| Office Action Summary | Application No. 10/525,816 | Applicant(s) SHICHIDA ET AL. | |

DETAILED ACTION

1. This Office Action based on the Response filed with the Office on October 6, 2008, regarding the SHICHIDA et al. application.
2. Claims 1, 3, and 7-13 are currently pending and have been fully considered.

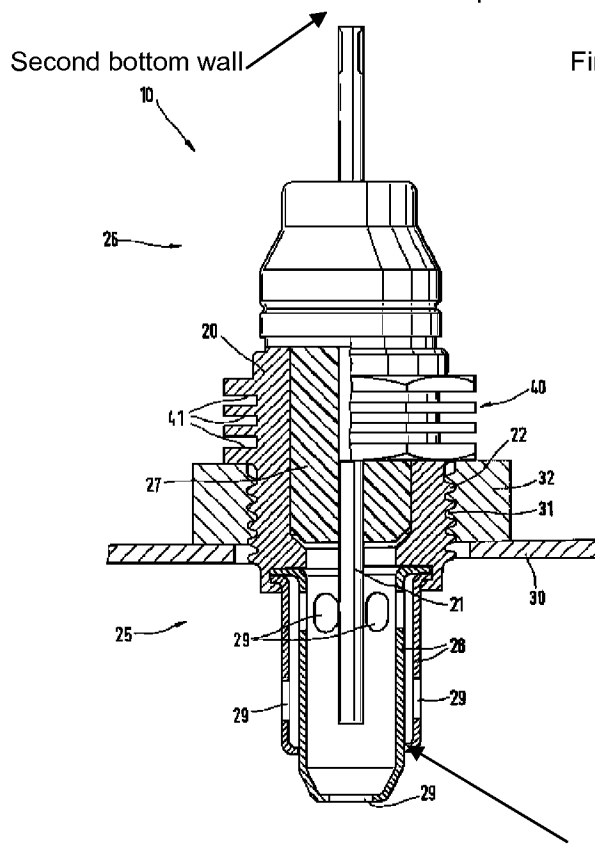
GRIESER additionally teaches the following configuration:

where the bottom lips can be taken as a first and second bottom walls of

First bottom wall, as annotated, and the second wall is in the first bottom wall, the discharge opening wall (29 in the figure), and a connecting side is has a taper so that the outer diameter at end. This configuration is structurally claim 13, as there is no convincing evidence s any functional significance, but is just a

structural difference that is shaped the same as the example found in the prior art.
